FINAL PLAT
IRON RIDGE FILING NO. 1
A PORTION OF THE SOUTHEAST QUARTER
SEC. 13, T11S, R66W OF THE 6TH P.M., COUNTY OF EL PASO, STATE OF COLORADO

PCD File No. SF2613

Project No.: 25183
April 29, 2026
Rev.: September 10, 2026
Sheet 1 of 2

FINAL PLAT
IRON RIDGE FILING NO. 1

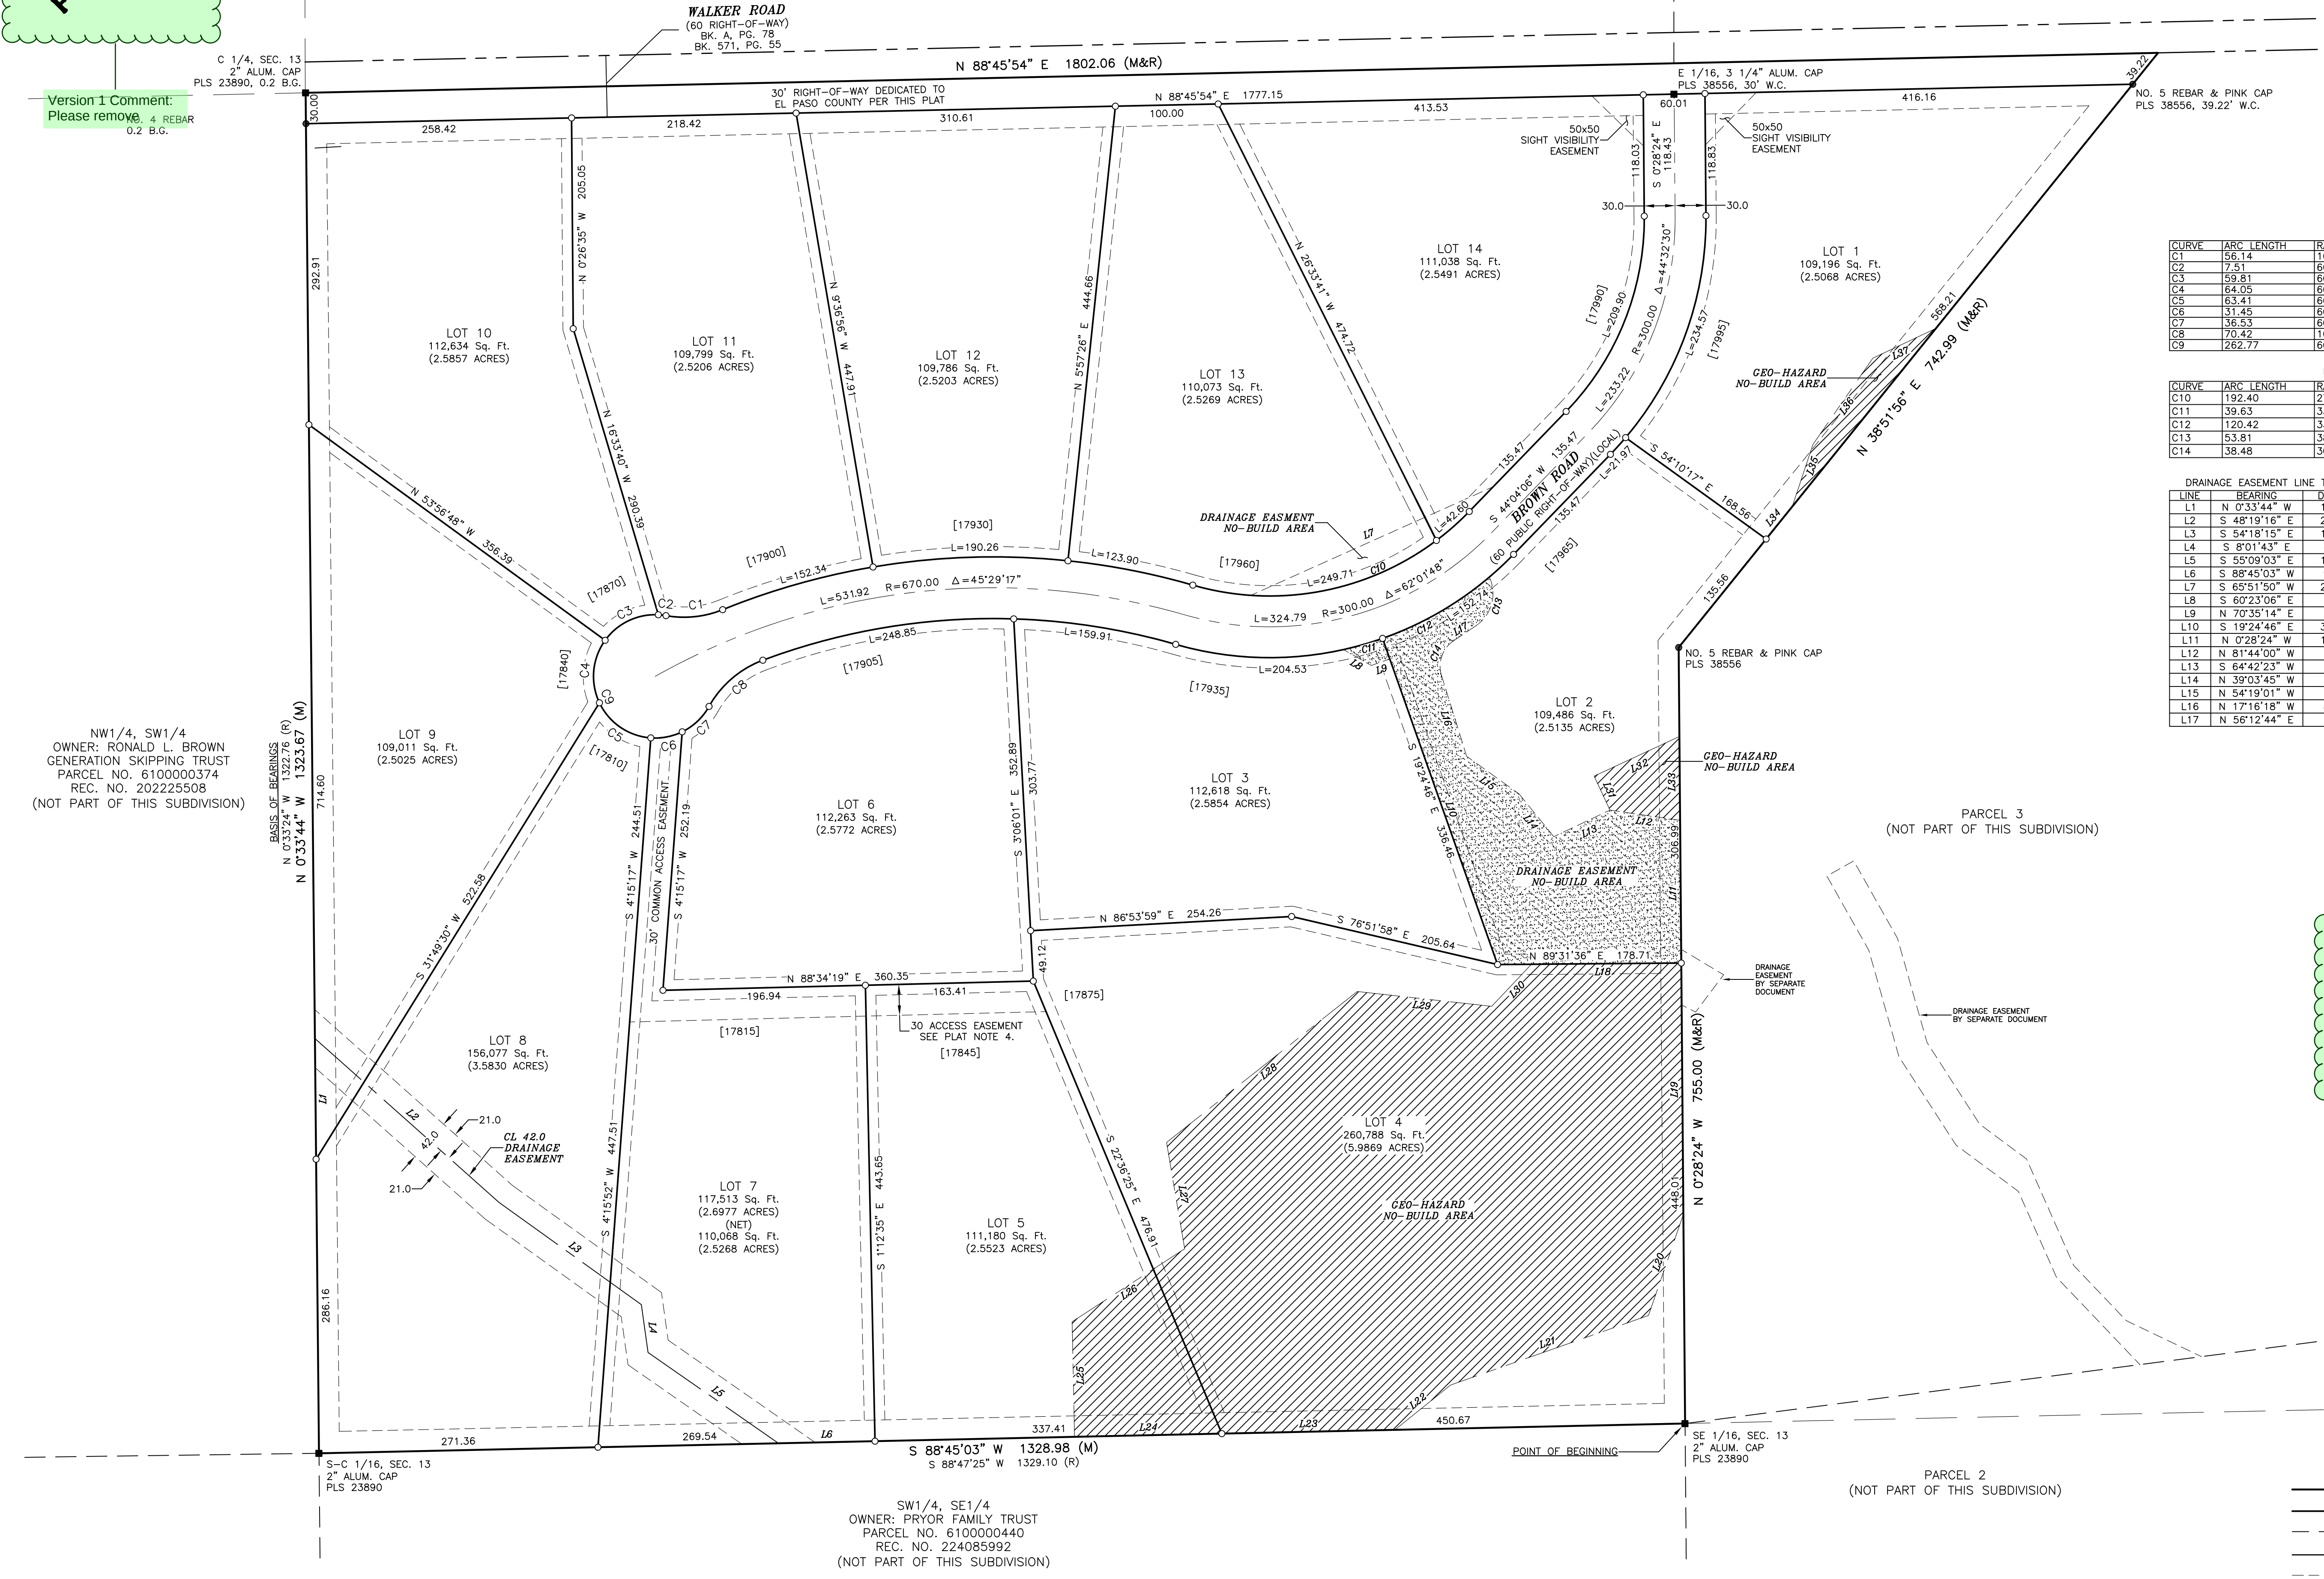
Version 1 Comment:
Please remove 4 REBAR
0.2 B.G.

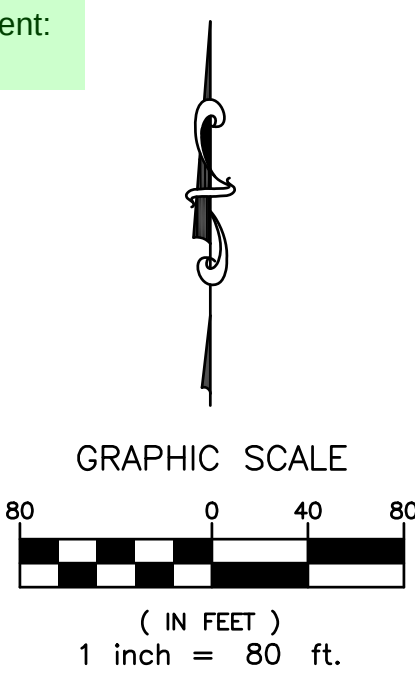
Version 1 Comment:
Please remove
